**REQUEST** Current Zoning: R-22MF (multi-family residential)  
Proposed Zoning: NS (neighborhood services)

**LOCATION** Approximately 0.87 acres located on the north side of Reece Road, east of Arbor Lane, east of Park Road, and north of the Park Road Shopping Center  
(Council District 6 - Bokhari)

**SUMMARY OF PETITION** The petition proposes to redevelop four existing single family home sites on Reece Road with up to 16 townhome dwelling units at a density of 18.39 units an acre.

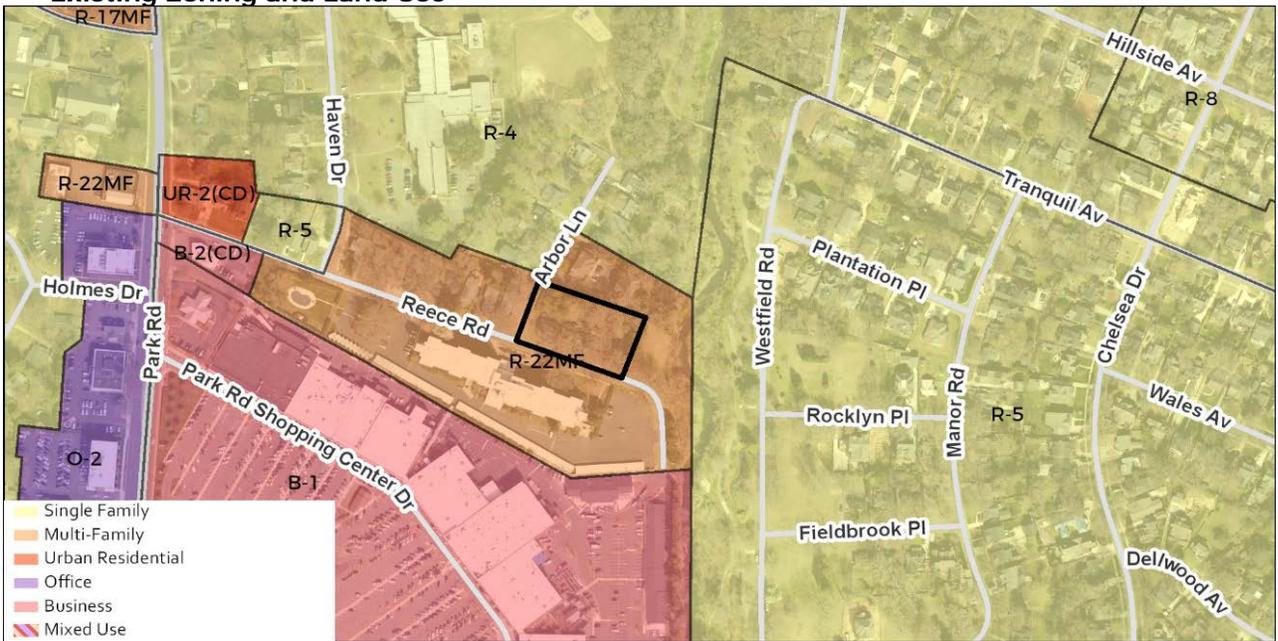
• **Proposed Request Details**

The site plan accompanying this petition contains the following provisions:

- Allows the development of up to ~~15~~ 16 single family, attached dwelling units ~~and one live-work unit.~~
- Eight-foot planting strip and six-foot sidewalk along Reece Road and Arbor Lane.
- Provides a number of architectural commitments related to building materials, roofing types, roof pitches, doors, windows, and design requirements for the facades along Arbor Lane.
- No expanse of blank wall will be allowed over 15 feet.
- Each unit will provide a minimum two car garage.
- Commits to a minimum 800 square feet for tree save, above the zoning minimum.
- Building elevations with building materials.
- Potential off-site evergreen screening on parcel 17518227 if permitted by the owner.
- Maximum building height of 50 feet.

1. ~~Provide a minimum square footage for the proposed tree save area.~~ Addressed
2. ~~Eliminate the live work component from the proposed request.~~ Addressed
3. ~~Add a note committing to the two four-unit buildings along Reece Road.~~ Addressed

4. ~~Submit a tree survey for all trees two inches in diameter at breast height (DBH) or larger located in the public right of way. Tree survey may be completed by landscape architect, surveyor, or other land development professional.~~ Addressed
